WABASHA PLANNING COMMISSION

SUBJECT: 1712 Hiawatha Dr E Solar Garden (IPS Development LLC)

To: Wabasha Planning Commission
From: Alex Conzemius, AICP
Date: May 26, 2020
Subject: CUP application – IPS Development, LLC

SITE PLAN

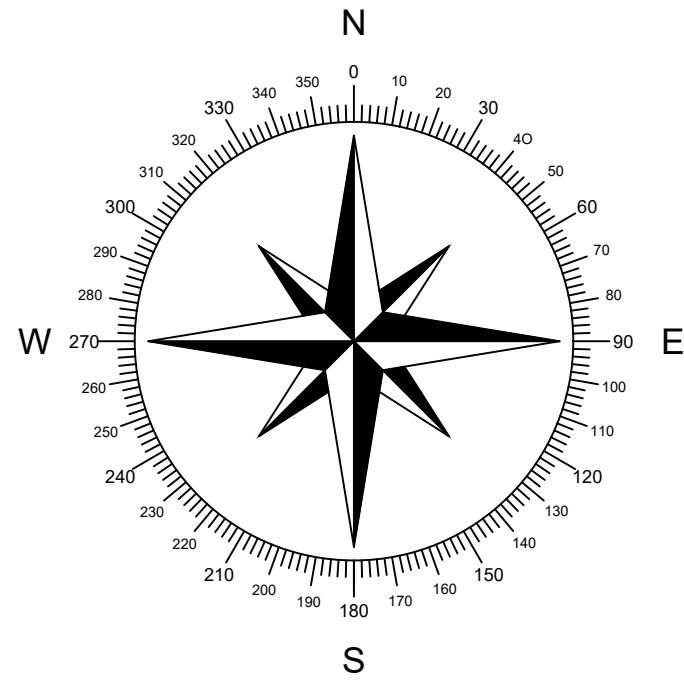
- Building inspector will certify the design as part of the building permit.
- Site plan shows a 15' wide drive to access the site. It is unclear the material proposed for the drive.

- A 8 foot galvanized fence is proposed for safety and security. Screening in the form of spruce evergreens are also proposed on the north lot line mitigating any visual effects on residential properties. The tree line appears that it would mostly block views, but additional plantings on a portion of the east fence of the proposed solar garden would be required to totally block views.

- Applicant should confirm that all on-site power will be buried so as to meet ordinance standards.
- Applicant should inform of any signage planned on the site. Signs must not exceed 32 square feet so as to require a IUP/CUP. Any sign is likely to require a permit.

- 1) All performance standards for a solar garden/farm are met.
- 2) Additional evergreens could/should be planted an additional 100 feet to the east or 200 feet to the south to fully screen the solar field from established residential neighborhoods.

- 3) All on-site power and communication lines running between solar panels and buildings shall be buried underground on the premise.
- 4) If the project disturbs more than 1-acre, a Construction SWPPP and Stormwater Management Plan Permit must be submitted and approved by the MPCA.

Approximate Floodplain Location

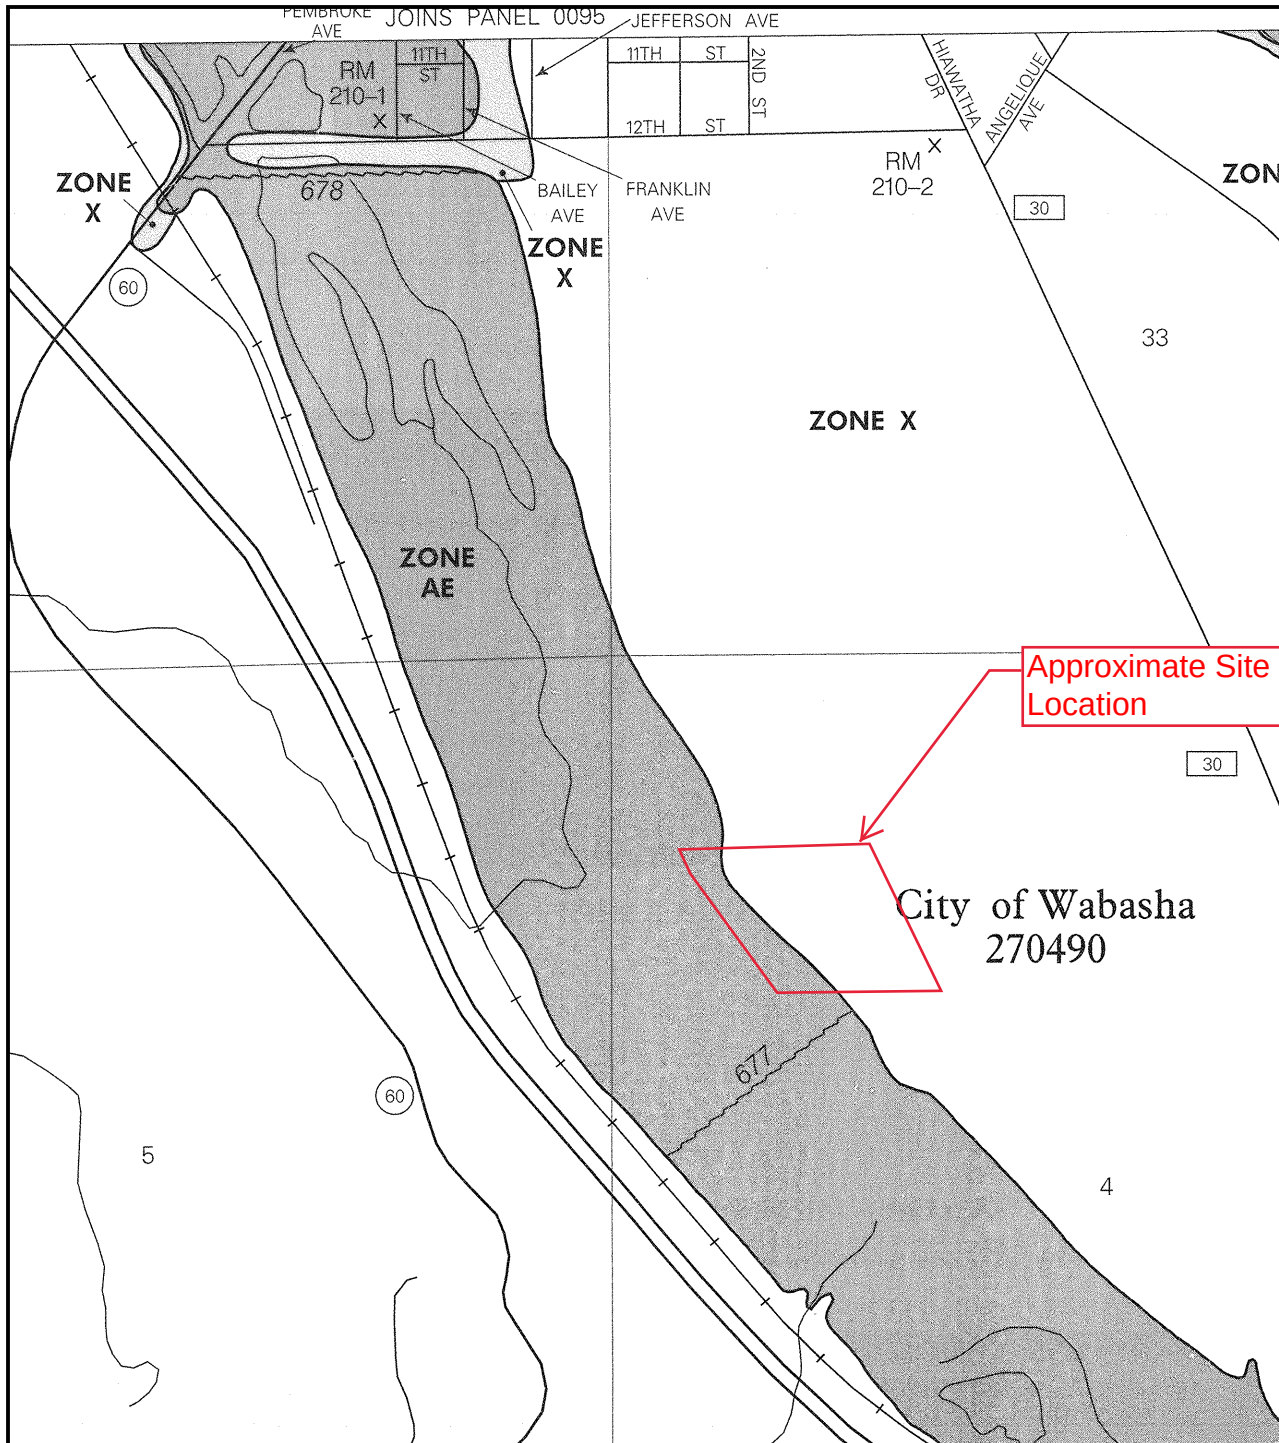
- Runoff will be mitigated through plantings on site and will be engineered as part of the building permit process.
- A portion of the property is located in the floodplain without a detailed study of Floodway/Flood Fringe. DNR requires a PE verify the floodwaters in this area would not be excessive or dangerous to life and property.

- 5) A grading plan must be approved by the City Engineer prior to the start of construction for the project.
- 6) A PE must verify the floodwaters in this area would not be excessive or dangerous to life and property.

- 7) Solar panels shall be elevated above the regulatory flood protection elevation (panels themselves, not necessarily support poles).
- 8) A decommissioning plan should be submitted and financial assurances provided to ensure the removal of the project from the site at the end of its useful life.
